**Report to General Manager**

SUBJECT: Victoria Cross - Over Station Development (OSD)

AUTHOR: Geoff Mossemeneer, Executive Planner

The purpose of this report is to describe the two applications/proposals, explain their relationship to each other and identify any concerns or issues that need to be addressed in the Department's determination of the applications for the OSD.

Picture 1 – Approved Building Envelope
Source: Bates Smart

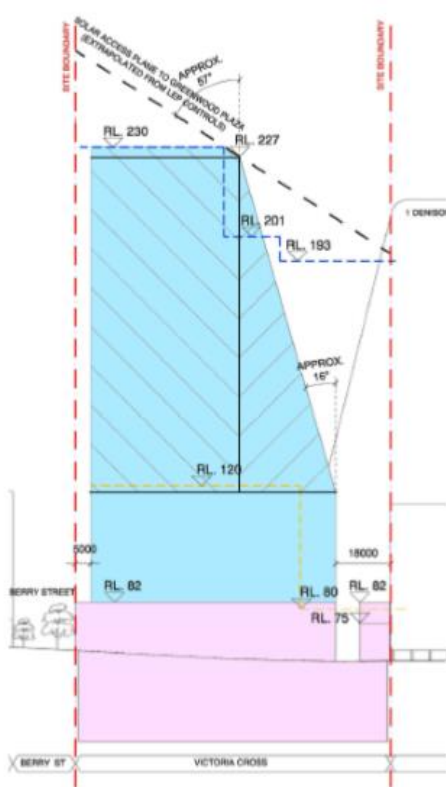
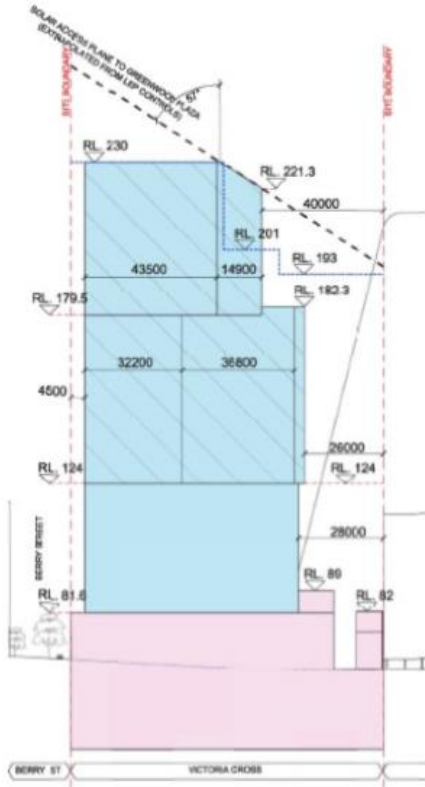
The proposed modifications reduce the bulk and scale of the building from the Miller Street Special Area, the through-site link, and Denison Street. The amendments made to the area through-site link is of interest and clearly a benefit.

The modifications to the Concept approval are considered reasonable and an improvement subject to the tower being setback on the Miller Street faced to at least be in line with the podium.

Picture 22 – Approved Building Envelope Indicative Ground Floor Plan

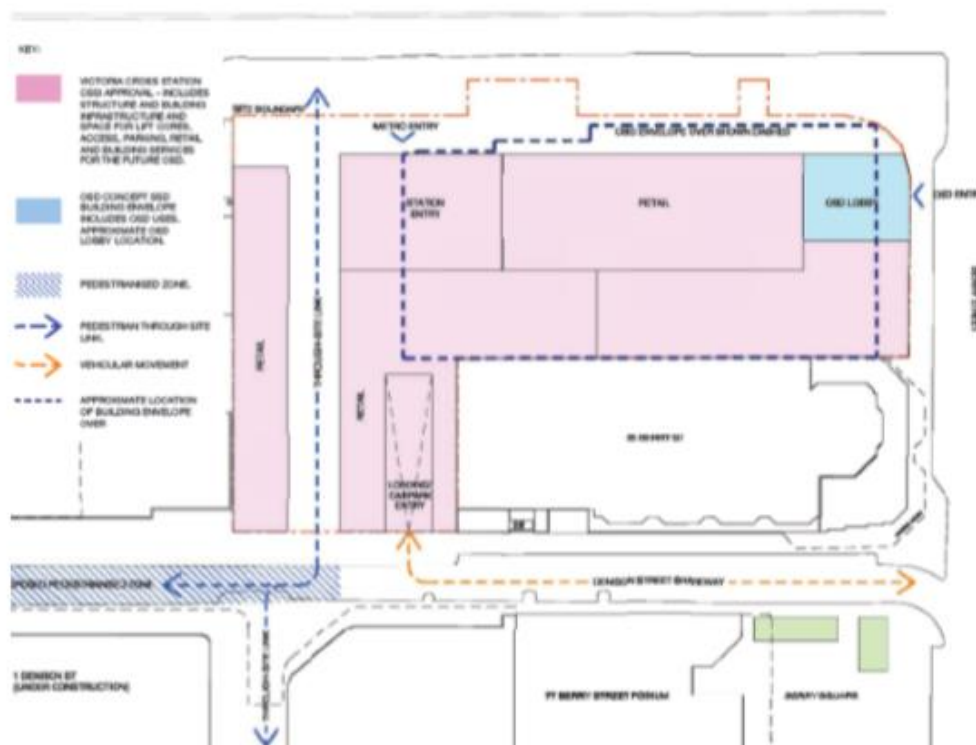
Council also raised the importance of allowing for future vehicle access through the parking area to the MLC site to improve pedestrian safety and remove vehicles from the lower part of Denison Street where a pedestrian plaza is proposed. Metro did not make this a requirement when appointing Lend Lease to develop the OSD. However, this could be made a condition of consent for the detailed application.

There is no relevant commentary in the EIS or the Traffic Assessment. The B1 floor plan does allow for a safeguarded link. There is no commitment for the access to be made available in the future to allow vehicle access to the MLC site. This is in the public interest to ensure no conflicts with pedestrians entering or exiting the site and the Metro station and using the Denison Street Plaza. The alternative access for MLC would be entry from Denison Street that would have a severe impact on the public domain in Spring Street, Denison Street, Mount Street and Brett Whiteley Place.

- 5. THAT** Council request the Department of Planning, Industry & Environment to impose a site-specific condition which requires legal vehicular and pedestrian access through the Metro and Metro Over Station Development sites to the MLC building.
-

Construction Pedestrian and Traffic Management Plan (Framework CPTMP)

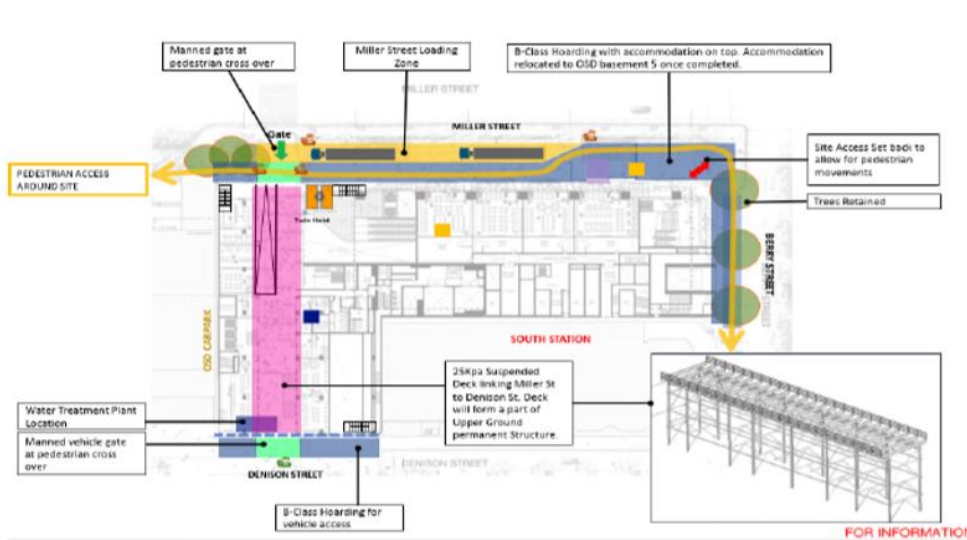
- provide a very narrow pedestrian facility for the volume of pedestrians that currently use Miller Street's eastern footpath (particularly in the evening peak when queuing bus passengers on the western footpath limit the flow of pedestrians along the opposite side of Miller Street);
- limit visual connectivity, due to the "dog-leg" in the proposed footpath, further impacting the security and amenity of pedestrians;
- require significant tree removal (for later replacement) along the site frontage; and
- limit the width of the gantry area adjacent to the construction/loading zone, which would result in the provision of unsightly multi-deck site accommodation structures around the Miller Street/Berry Street junction.

For the Metro CTMP, it is recommended that the Metro loading/construction zone be provided in Miller Street's southbound kerbside lane along the length of the Metro site for the duration of the construction period (2020-2024). This would reduce southbound lanes on Miller Street to a single mixed-traffic lane. Modelling undertaken as part of the development of the North Sydney CBD Transport Masterplan showed that this would not significantly impact intersection level of service due the majority of traffic in the kerbside lane north of Berry Street turning left on to Berry Street to access the Warringah Freeway.

- 3. THAT** Council support the use of Miller Street's southbound, kerbside lane along the frontage of the Metro site for a loading/construction zone during the Metro and Metro OSD construction period.
